✓
TECHNICAL REPORT NO. 13

COLUMBIA-COWLITZ-TOUTLE RIVERS, WASHINGTON, RESTORATION SUBSEQUENT TO MT. ST. HELENS ERUPTION

September 1985

Committee on Channel Stabilization
CORPS OF ENGINEERS, US ARMY

Figure 1. Location map

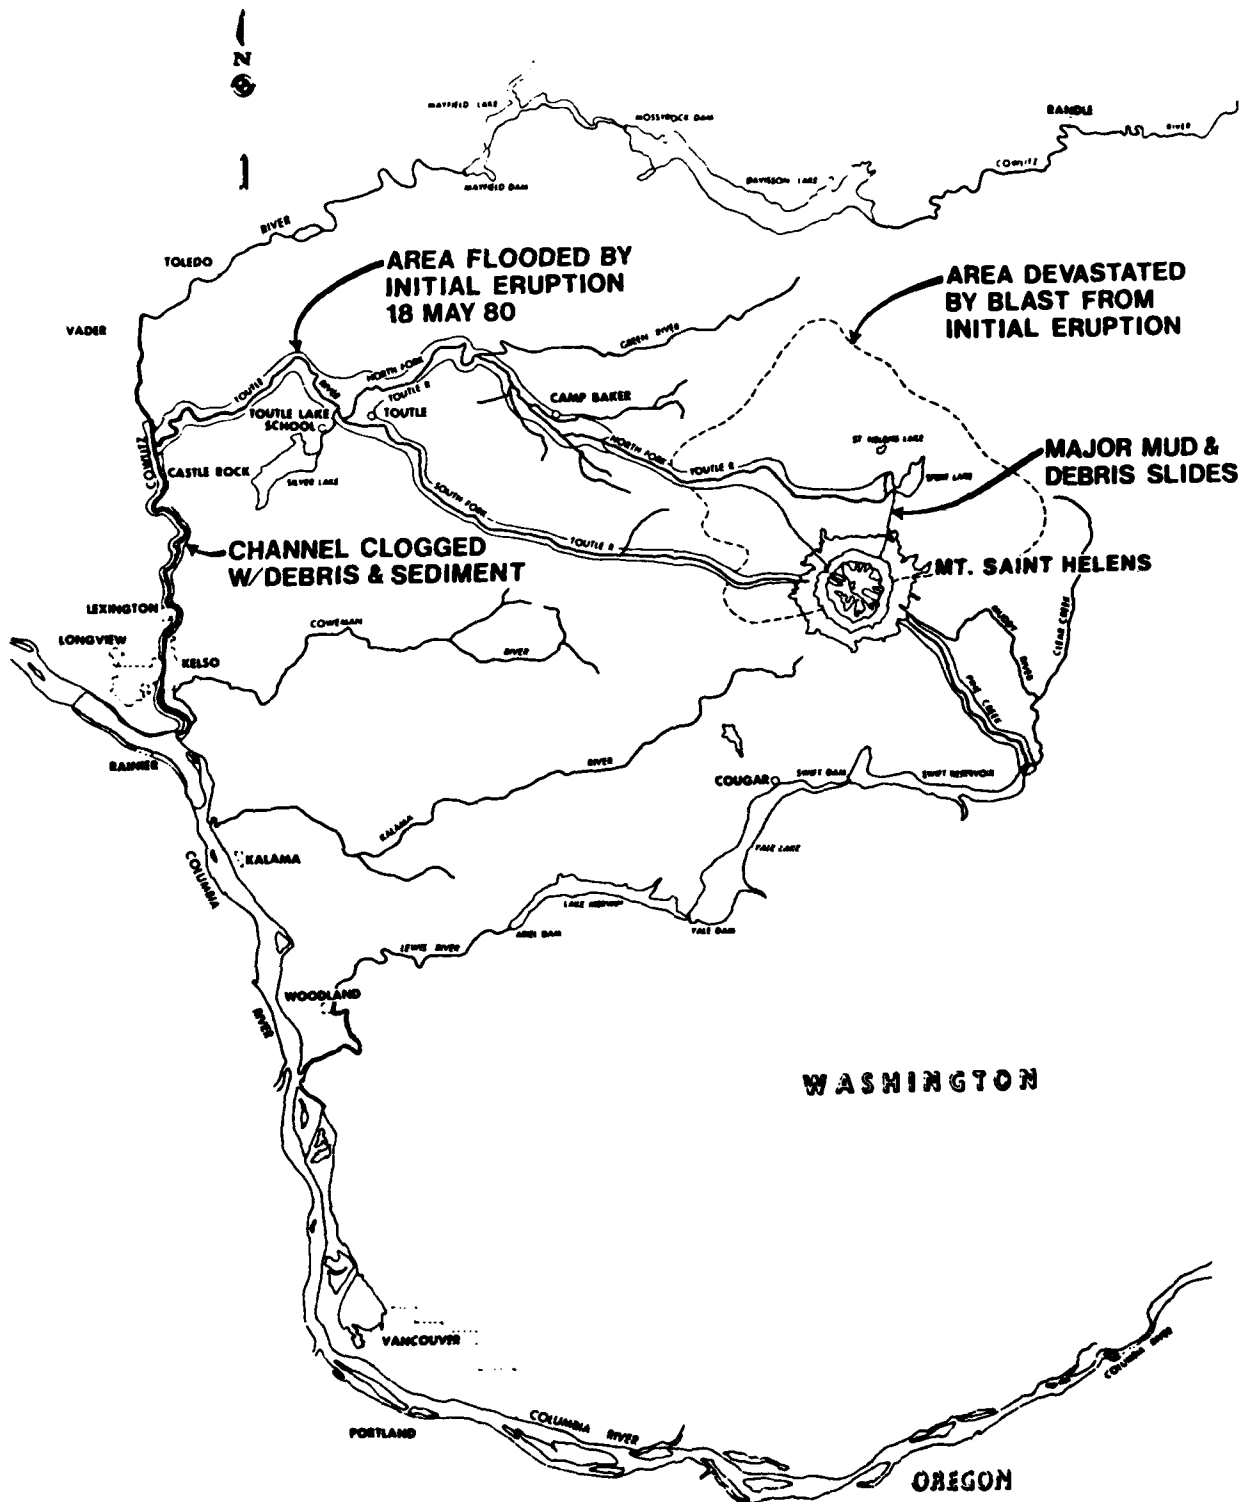
21. Debris retaining structures. A debris-retaining structure was constructed on each fork of the Toutle River (Figure 1) for the purpose of trapping sediment, thereby keeping it out of the Cowlitz and Columbia Rivers. Justification for the structure was that a bucket of material removed from the Toutle River equaled one less bucket of material to be handled in the Cowlitz and Columbia Rivers. Portland District indicated and it was observed on the 3 December field trip that each structure filled rapidly. Subsequently, the District began removing material upstream of South Fork structure and planned to initiate similar operations at the North Fork structure. The Committee suggests that the District take a serious look at the real benefit of these structures. In the short term, the material removed from the system by the structure may not affect the sediment loads arriving at the mouth of the Toutle at all. The Toutle has a definite transport capacity and assuming unlimited supply of material upstream and downstream of these structures, material removed by the structures will be replaced by material available for transport downstream of the structures. Over the long term, the operation of trapping and removing material, causing scour and downcutting of the river below the structures, could be detrimental rather than beneficial. The floor of the upper valley of the Toutle River has been raised. If allowed to establish a

new regime, supplemented by an armoring process and encouraged by stabilization efforts, the Toutle could acquire a new slope commensurate with slopes produced by the raising of the valley floor. This process, which is a natural process, could be far more beneficial in annual reduction of sediment loads transported than the present plan of operation at the two structures which in fact disrupts the natural healing process.
